Access Compliance Report

Public Rights-of-Way

(Curb Ramps)

Intersection ID: 29810	Main Street: MCCLURE_MANOR_DR	Cross Street: SYDENHAM_CT	Location: NW
ADA ID: 6DCDA8A1261E	Ramp Type: BlendTrans2	Initial Pass/Fail: Fail	Overall Compliance: No
Severity Score: 25			
Codes/Mitigation Info/Possible Solution		Field Measurements/Component Compliance

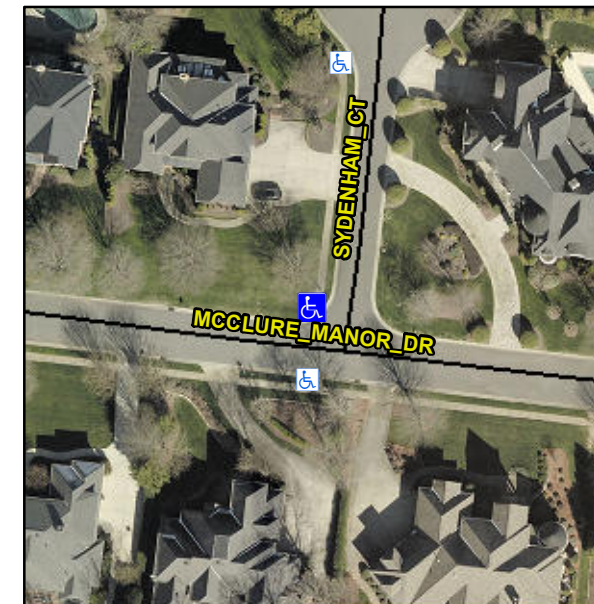
DAMAGED RAMP

Not Found, R304.5.3

Compliance	Description	Data	Compliance	Description	Data
N/A	Ramp Length (in)	98.0	Yes	BlendTrans Slope (%)	3.4
Yes	Ramp Width (in)	85.0	No	BlendTrans XSlope (%)	15.0
N/A	Flare Type LT	N/A	N/A	Flare Type RT	N/A
N/A	Flare Slope LT (%)	N/A	N/A	Flare Slope RT (%)	N/A
N/A	Flare Traversable LT?	N/A	N/A	Flare Traversable RT?	N/A
N/A	Landing Length (in)	N/A	N/A	DWS Provided?	N/A
N/A	Landing Width (in)	N/A	N/A	DWS Contrast?	N/A
N/A	Landing Slope (%)	N/A	N/A	DWS Length (in)	N/A
N/A	Landing X Slope (%)	N/A	N/A	DWS Full Width?	N/A
N/A	Landing Curb? (Y/N)	N/A	N/A	DWS Offset (in)	N/A
N/A	Shared Landing?	N/A			
N/A	Gutter Ponding?	N/A	N/A	Gutter Slope (%)	N/A
N/A	Gutter Lip Ht (in)	N/A	N/A	Gutter X Slope (%)	N/A
N/A	Painted X Walk1?	No	N/A	Painted X Walk2?	No
	X Walk 1 Direction	To S		X Walk 2 Direction	To E
	X Walk 1 Width (in)	N/A		X Walk 2 Width (in)	N/A
	X Walk 1 Slope (%)	7.0		X Walk 2 Slope (%)	3.1
	X Walk 1 X Slope (%)	8.6		X Walk 2 X Slope (%)	8.5

Remove & Replace Curb Ramp With Two New Directional Ramps or Equivalent.
